Request for Information (RFI)

Project:	The Big Business District	RFI No.:	BD-CW-SAMCO-PCO-RFI-MECH-003
Owner:	ROYA Developments	Rev.:	R00
Project Manager:	ACE-PM	Date:	08 / 03 / 2026
Consultant:	Prime Consultant		
Contractor:	SAMCO National Construction		
To:	PCO

Discrepancy in Sump Pit Configuration Between Structural approved shopdrawing and Mechanical Drawing – Basement 2

SHOP DRAWING (SDW)

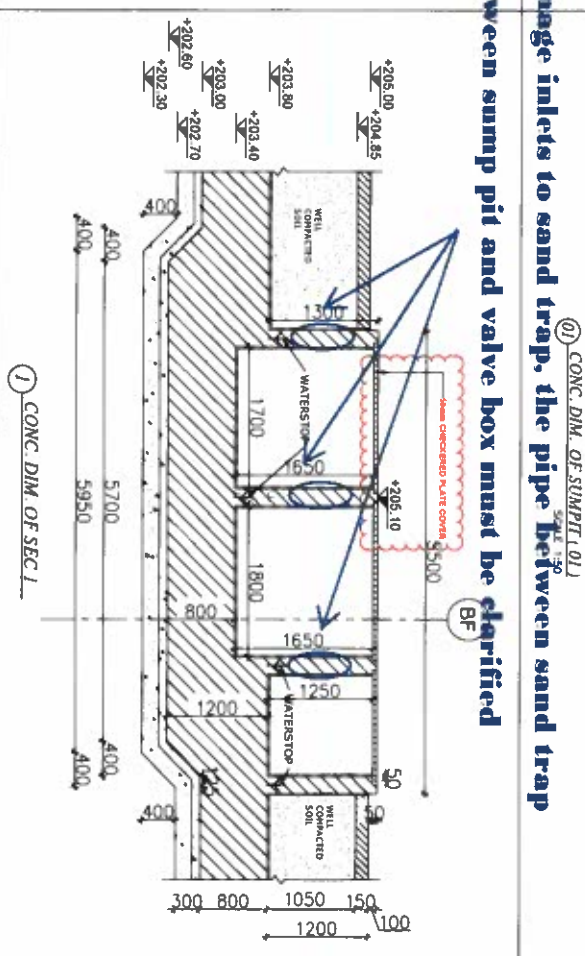
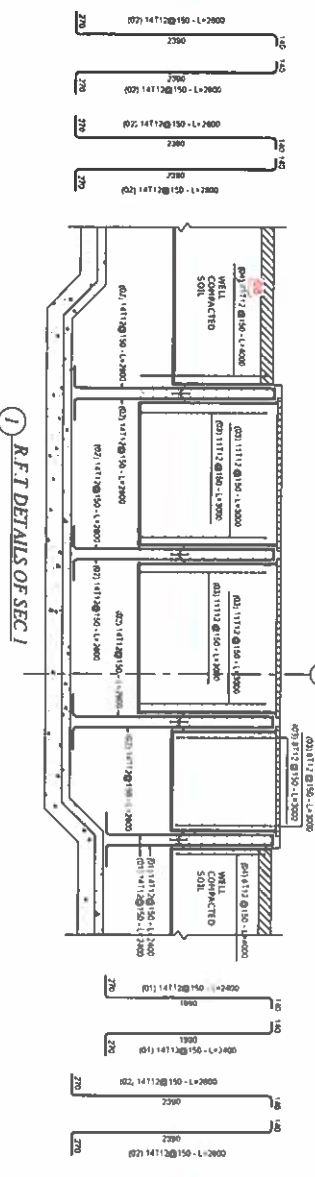
The level and location of drainage inlets to sand trap, the pipe between sand trap and sump pit and the pipe between sump pit and valve box must be clarified

The level and location of drainage inlets to sand trap, the pipe between sand trap and sump pit and the pipe between sump pit and valve box must be clarified

02 R.F.T. OF SUMPIT (02)

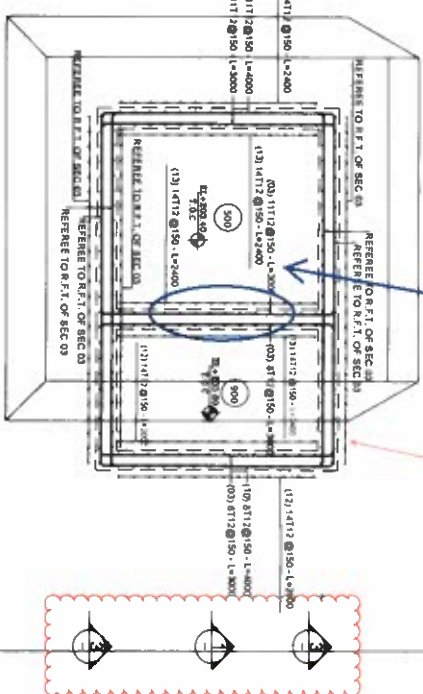
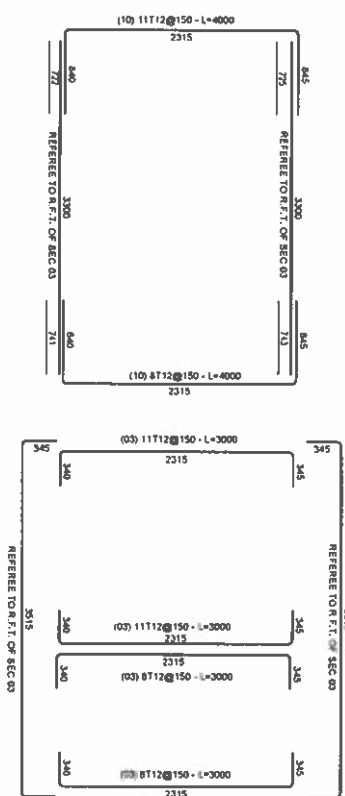
- The level and location of penetrating pipes (inlets to sand trap/between sand trap

- Provide paddle flanges on all penetrating pipes (24)
- All opening thru concrete must be submitted after approval MEP work... (25)
- (26)
- (27)

The level and location of drainage inlets to sump pit & between sump pit and valve box must be clarified

The level and location of drainage pipe between sump pit and valve box must be clarified

Sections mark should be shown on RFT plan

01 R.F.T. DETAILS OF SEC 1

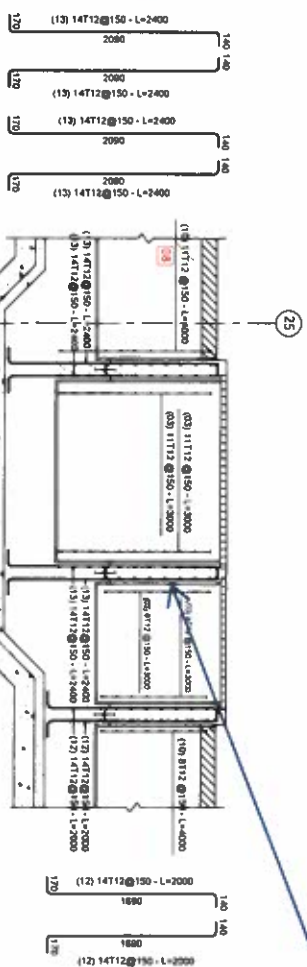
The level and location of pipe between sump pit and valve box must be clarified
